Re: BusConnects Lucan to City Centre Core Bus Corridor Scheme

Subject: Observation on permanent acquisition of lands on NTA map 1023(1).1f

Lucan to City Centre Core Bus Corridor Scheme Compulsory Purchase Order 2022

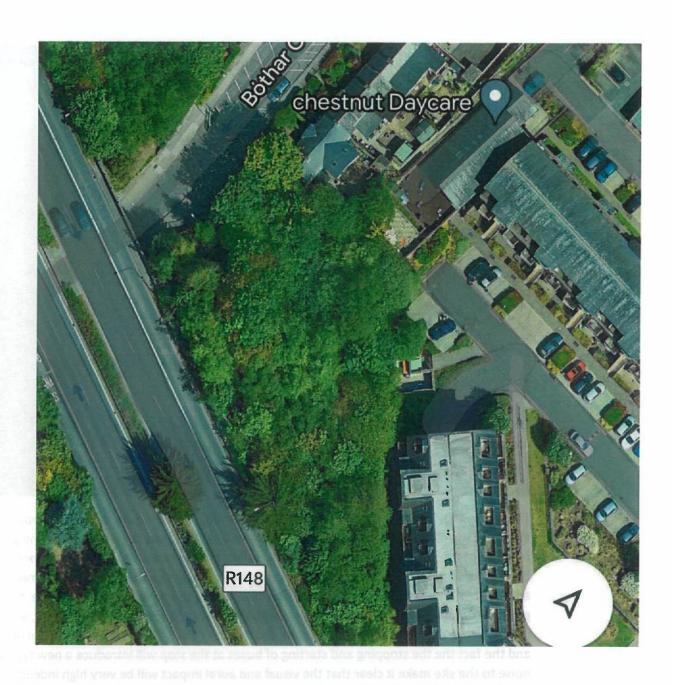
I wish to object in the strongest terms to the Compulsory Purchase Order on the above named lands and in particular to the proposal to develop a bus stop there.

The land in question is a steep densely wooded embankment which rises from the ground level at Knockmaree apartments to approximately a third story height. It is proposed to:

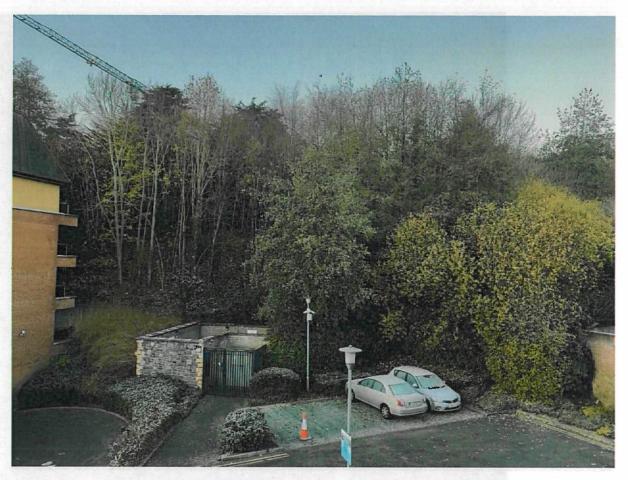
Remove almost all trees from the current embankment. The approximate number of trees to be removed is shown on this map. The location of my home is marked with a blue line on the right of the map. For context, a Google Maps Screenshot follows the map. This screenshot shows the current extent and density of the woodland, which would all be lost were the proposed site to be used and the proposed design implemented.

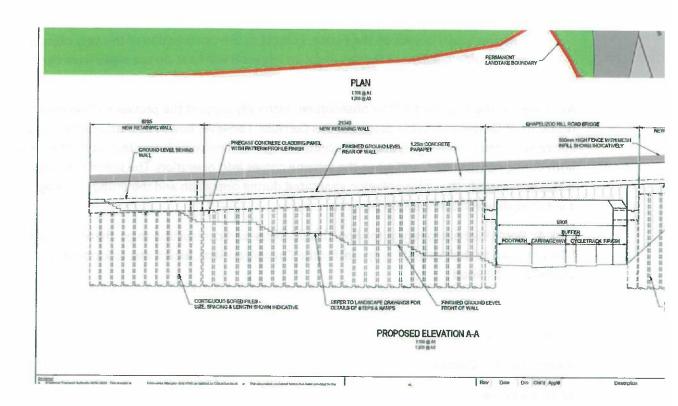
Further views, firstly from a Google Maps Streetview Screenshot and secondly from the second floor of my home, provide more views of the woodland to be removed.

The removal of the woods shown on these images will, apart from the ecological impact, also have the effect of completely removing the N4 light and sound pollution screening function of the trees. Little detail of how this might be alleviated is given in the proposal, and there is no visual mock up of how the proposed stop will appear from the Knockmaree apartments. However, the indicative design description, the steep incline of the site, the proposed widening of the N4 at this spot by two lane widths (one for the stop itself, and one for the necessarily long wheelchair ramp), the written detail of the proposed contruction, and the fact the the stopping and starting of buses at the stop will introduce a new type of noise to the site make it clear that the visual and aural impact will be very high indeed. The visual and aural impact will be all the higher as the proposed stop will be approximately three stories above ground, which will make the increase in noise audible over greater distances within the site. I object to this because it will result in a very large increase in the sound and light pollution in our home, impacting in a very negative way on our enjoyment of our home
